**Request for Additional Information No. 133. Supplement 6**

**U. S. EPR Standard Design Certification**

**Docket No. 52-020**

**Question 19-230:**

**Figure 19-230-1—Lateral RPV Failure Configuration**

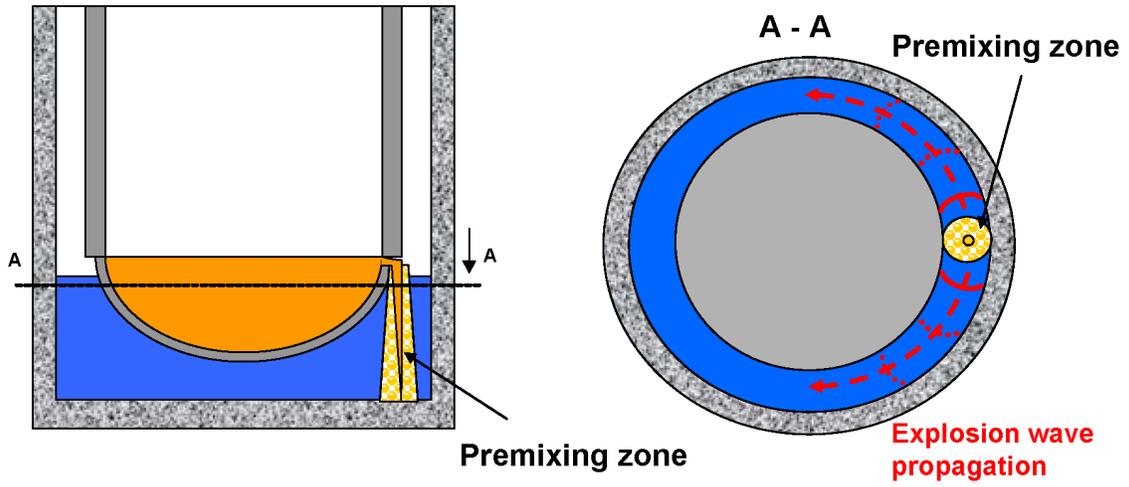
- a. The approach described in the response appears to be subjective. One acceptable approach to this problem is to determine the threshold impulse load at which the pit structure will have zero probability of failure (i.e., this approach is typically considered as bounding. For instance, in other recent submittals, the DYNA 3D model was used to establish the impulse threshold for the portion of containment that was subject to steam explosion-induced impulse loads). Please perform a mechanistic analysis that supports the assigned uncertainty distribution.

- d. Please provide the range of expected loads on the RPV, and if there is any potential for RPV uplift impacting containment penetrations.
- e. Please provide an analysis of the impact of the reactor pit failure on severe accident progression for U.S. EPR.

- The lateral failure mode represents 94 percent of the RPV failure modes.
- The central failure scenario represents 5 percent of the RPV failure modes.

Tables 19-230-2 and 19-230-3 present the steam explosion loads resulting from a lateral melt outflow for oxidic and metallic melt compositions, respectively. The peak and average values of these pressure loads, as well as the impulse loads for the lateral melt outflow, are relevant for evaluating the reactor pit wall integrity.

**Table 19.1-24—Internal Events Release Category Results - Large Release  
Frequency  
Sheet 1 of 2**

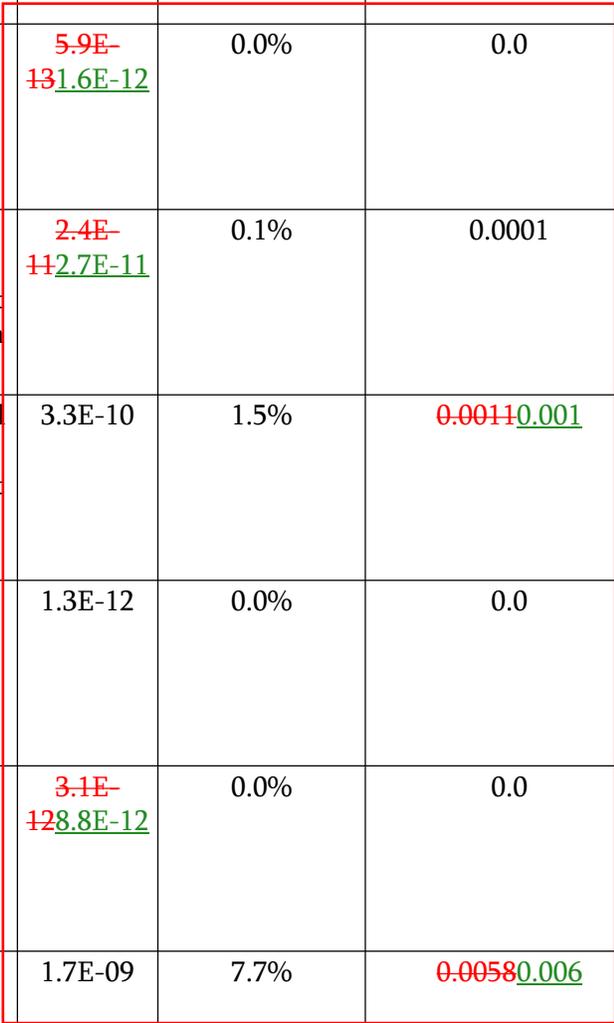
(Follow-up to Question 19-147) In response to Question 19-147, the applicant provided a subjective probability distribution for structural capacity of the EPR reactor pit for dynamic pressure loads. Table 19-147-1 shows that the reactor pit is expected to fail with certainty for loads exceeding 20 kPa-s. NRC assessment of ex-vessel steam explosion loads (NUREG/CR-6849) under similar conditions show maximum loads resulting from FCI energetics ranging from about as low as 10 to as high as a several hundred kPa-s, depending on the melt pour and analysis assumptions and conditions.

- Section 19.1.4.2 will be revised to include the new ex-vessel steam explosion evaluation methodology and the revised release category frequencies for internal event LRF.
- Tables 19.1-24, 19.1-50, 19.1-75 and 19.1-105 will be revised to include the revised release category frequencies for LRF.
- Table 19.1-25 will be revised to include updated significant cutsets for internal events LRF.
